FCC ID: TCB Approval E5M-INET900

Applicant: Microwave Data Systems, Incorporated Correspondence Reference Number: 3626 731 Confirmation Number: TC363980 Date of Original Email: 03/01/2002

Figure 1 (20 dB Bandwidth: 256 kbps/2-level @ 902.5 MHz)

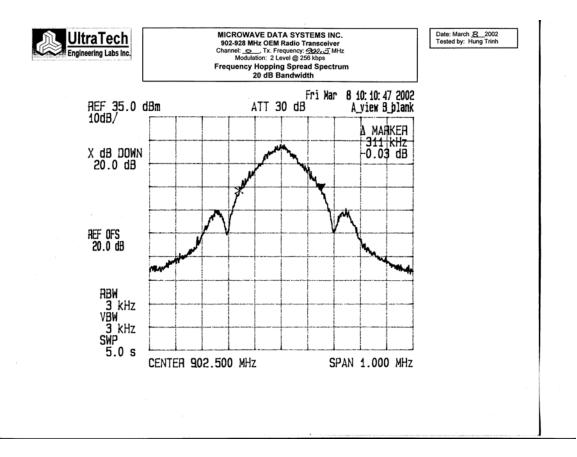
The Test Report data shows a channel spacing of 333 kHz and channel separation of 317 kHz. The bandwidth is greater than the channel spacing, which is not compliant with the provisions of Section 15.247(a)(1) of the Rules. Explain this non-compliance.

The test data provided for the 2-level 20 db occupied bandwidth would lead one to believe that the MDS INET900 is non compliant in that mode. The attached re-run plot of the 20 dB occupied bandwidth for the 2-level mode of the original MDS INET900 test unit clearly shows that the MDS INET900 is also compliant in the 2-level mode. The only explanation we can offer for the original non-compliance is that conceivably during the process of setting the MDS INET900 in the 2-level mode a mis-configuration in the deviation register must have occurred. End users do not have the ability to adjust these registers.

To ensure that there are no such issues with any other measurements all measurements specific to the 2 –level mode and occupied bandwidth (20 dB bandwidth, Band-edge Compliance) were re-run with random data. Full compliance was further revalidated. These plots are also attached.

Figure 8 (Number of Hopping Frequencies: 902-915 MHz)

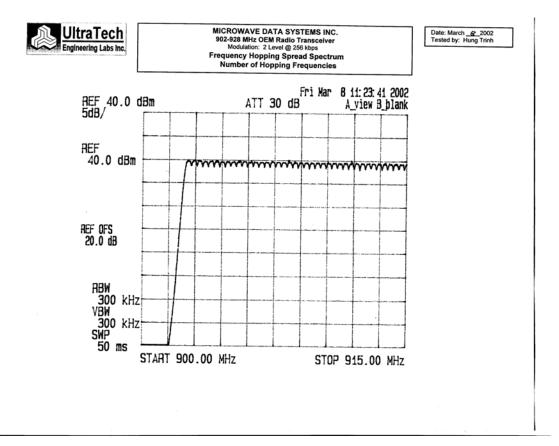
The Test report states that there are 80 hopping channels. However there is no data or spectral plots to support this. Upload spectrum plots showing compliance with the number of hopping channels.

Enclosed are spectral plots showing the MDS iNET900 hopping on 80 channels.
